# Service Bulletin

**SUBJECT:** Service Update for Inventory Vehicles Only  
Rear Glass Water Leak  
Expires September 30, 2015

**MODELS:** 2014 Chevrolet Cruze

3613309

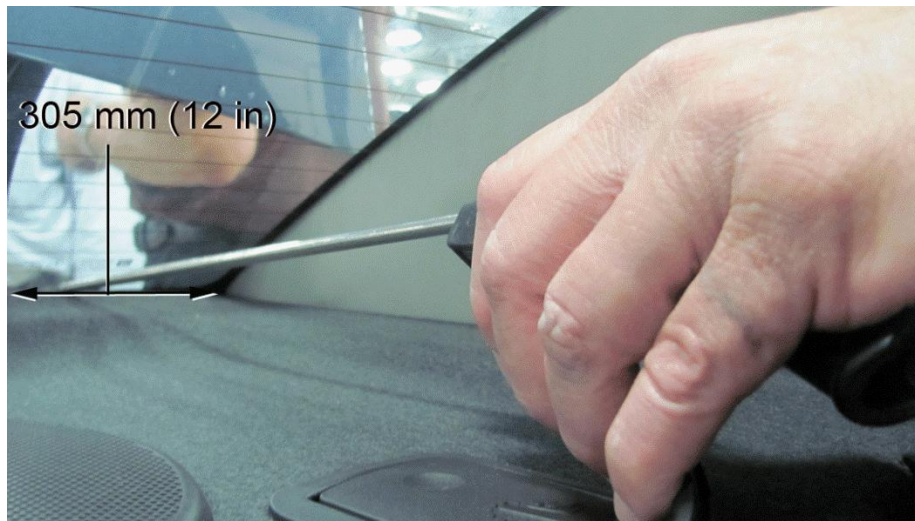
**Note:** Some vehicles may have a urethane sealing issue in the area shown in the photograph. The area of concern is a 305 mm (12 in) section of the rear window glass that begins at the left (driver side) lower corner and ends near the CHMSL. The urethane sealing issue, if present, may allow water to enter the trunk. Look for evidence of a water leak in the trunk.

1. Locate the rear left (driver side) window glass (1) and rear window water deflector (2).

2. Apply a soap and water solution under the water deflector in the 305 mm (12 in) section of the rear glass shown in the photograph.

**Note:** Have a second technician sit in the rear seat of the vehicle to apply air pressure to the rear glass during and after step 2. Use a small air nozzle to apply compressed air to the inspection area. Refer to photograph.

3. Apply compressed air to the bottom edge of the rear glass in the inspection area indicated in the photograph.
4. Determine if a water leak is present. Examine the soap and water solution to determine if a water leak is present.
  - If a water leak is NOT present, no further action is required.
  - If a water leak is present, remove and replace the rear window glass. Refer to *Rear Window Replacement* in SI.
